Rinnai New Product Update

E-SERIES BOILERS - NEWLY CONTENTED

PRODUCT CHANGE OVERVIEW

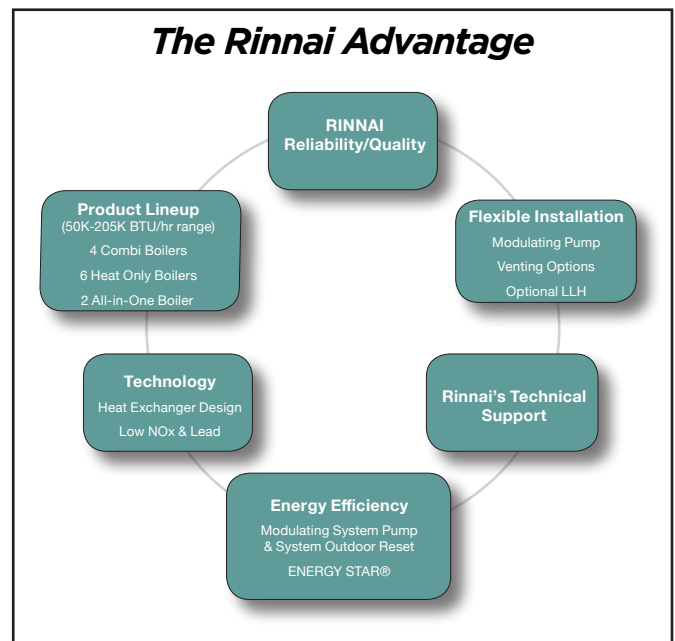
Products	Models	Boiler Type	Rating Input (BTU/hr)	DHW ($\Delta T @ 75^{\circ}F$)	Venting	Exp. Tank	Low Loss Header	Boiler Pump Type	DHW Plate HEX	Cover Door	Logo
Current	E50C	Combi	13.7K-50K	2.1 GPM	Concentric PVC 3"	Included	Included	3 Speed (Manual Switch)	Included	Solid Gray	Red (PMS 200)
	E75C	Combi	13.7-75K	2.1 GPM	Concentric PVC 3"	Included	Included	3 Speed (Manual Switch)	Included	Transparent Smoke	Chrome
	E110C	Combi	26K-110K	3.2 GPM	Concentric PVC 3"	Included	Included	3 Speed (Manual Switch)	Included	Transparent Smoke	Chrome
Newly Contented E-Series	E50CR	Combi	13.7K-50K	2.1 GPM	Concentric PVC 2" & 3"	Not Included	Accessory	Modulating (PWM)	Included	Transparent Smoke	Red (PMS 200)
	E75CR	Combi	13.7K-75K	2.1 GPM	Concentric PVC 2" & 3"	Not Included	Accessory	Modulating (PWM)	Included	Transparent Smoke	Red (PMS 200)
	E110CR	Combi	26K-110K	3.2 GPM	Concentric PVC 2" & 3"	Not Included	Accessory	Modulating (PWM)	Included	Transparent Smoke	Red (PMS 200)

E60SR	Heat Only	13.7K-60K	N/A	Concentric PVC 2" & 3"	Not Included	Accessory	Modulating (PWM)	N/A	Transparent Smoke	Red (PMS 200)
	E85SR	Heat Only	13.7K-85K	N/A	Concentric PVC 2" & 3"	Not Included	Accessory	Modulating (PWM)	N/A	Transparent Smoke	Red (PMS 200)
	E110SR	Heat Only	26K-110K	N/A	Concentric PVC 2" & 3"	Not Included	Accessory	Modulating (PWM)	N/A	Transparent Smoke	Red (PMS 200)

Red and yellow highlights indicate changes.
